*Proceedings of the Madras Government, Public Works Department,
29th September 1875.*

ROUGH SKETCH OF NEGAPATAM CREEK

Existing arrangements
at the Port of Negapatam.

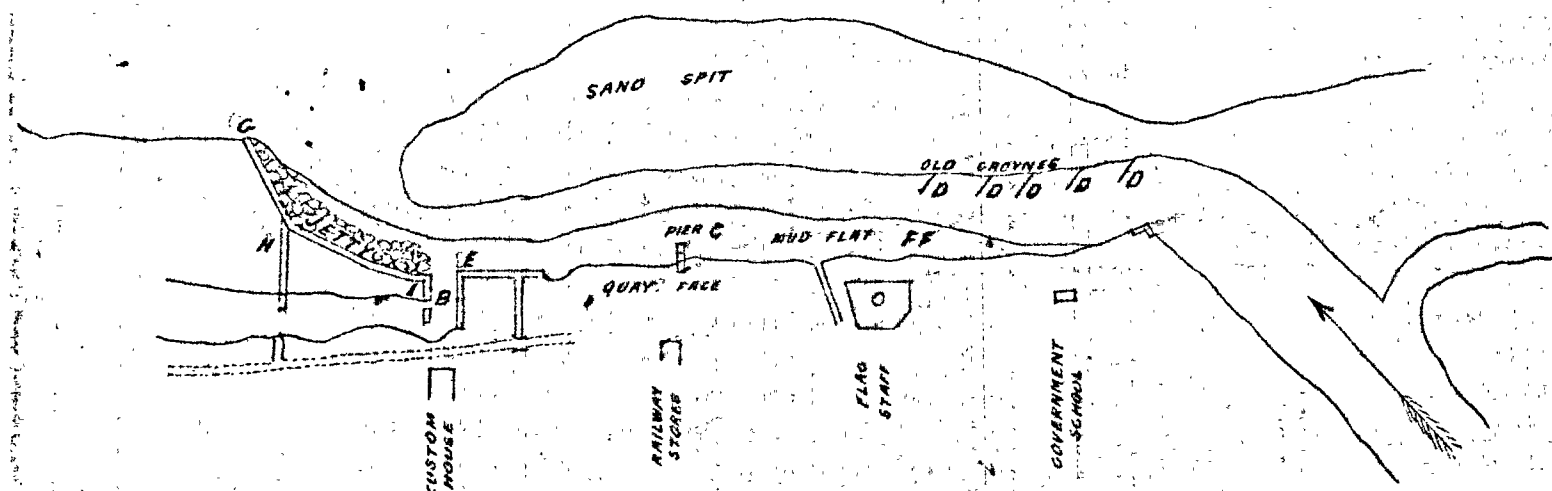
2. The mud flat (F F) is in front of the Railway Pier (C), and it is proposed to remove it by repairing the old groynes at D D and higher up the river. I understood the groynes were to be extended to remove the mud accumulated in front of the jetty (I H G), and I objected to the set being turned on the jetty. I see no objection to the groynes being extended so as to wash away the mud flat (F F), the fact of the mud flat having formed is, I think, a proof of the old groynes having been allowed to deteriorate.

3. As regards the removal of the stone thrown in along the face of the jetty wall to below low water mark so as to enable boats to approach the jetty, I am of opinion that from G to H or thereabouts the stone had better not be touched, as the action of the waves along the face wall base is considerable. From H to I the stone can be removed, as suggested, by Major Smith, provided the foundations of the jetty wall are sound for some few feet below L. W. M.; not having seen this part of the work done, I cannot answer for the depth of the foundations.

5. The accommodation for loading goods is very defective, and I suggested at one time the erection of a timber staging from I towards II, and the cleaning out of the boat basin (B) periodically; at that time the jetty wall from E towards C was, for some reason, not used for landing goods, but I understand it can now be used, and, therefore, there is more room for landing goods.

The mud flat (F F) is in front of the Railway Pier (C) and it is proposed to remove it by repairing the old groynes at D D and higher up the river.

Communicated to the Superintending Engineer in charge of Tanjore District, who will give his attention to the subject and submit in due course his proposals for removal of the mud flat, rendering the jetty wall more accessible, and improving the present state of the wharf generally at a moderate cost.
